Image 1: Building heights in the immediate area.

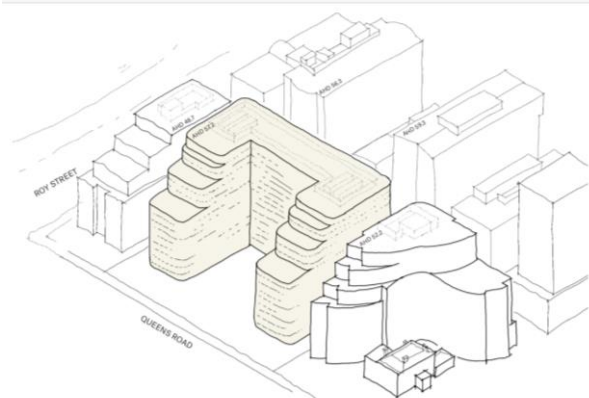
In considering this variation, it is considered that the variation would be acceptable. Whilst the development would exceed the discretionary height control, it would still be below the mandatory height control, by 11.2 m (to roof level) and 5.6 m to the plant screen. It is noted that this section of the development would have the smallest footprint and greatest setback to Queens Road. It is also noted that the adjoining development are both above the discretionary height control (40.73m – 1 Roy Street) and (44.21 m – 55 Queens Road). As such, it is not out of character in the immediate area for developments to exceed 40 m in height. One of the key sub-precinct objective of Queens Road is to “To reinforce the primacy of the St Kilda Road boulevard by creating a preferred future built form which provides a transition down in height from the high rise buildings along St Kilda Road to medium rise buildings along Queens Road”. In considering the proposed development height against the immediately abutting properties the following is note.

To the rear of the site No. 564 St Kilda Road would be 0.9 m lower than the proposal. No. 566 would be significantly lower as it is only eight storeys and No 568 would be 2.1 m higher than the proposal. The adjoining properties at No. 1 Roy Street and 55 Queens Road would be 8.5 m and 7.2 m lower respectively.

It is noted that of the three properties to the rear of the site (562, 564 and 568 St Kilda Road) one of the properties would be higher, one would be significantly lower and one would be just below the height of the proposal.
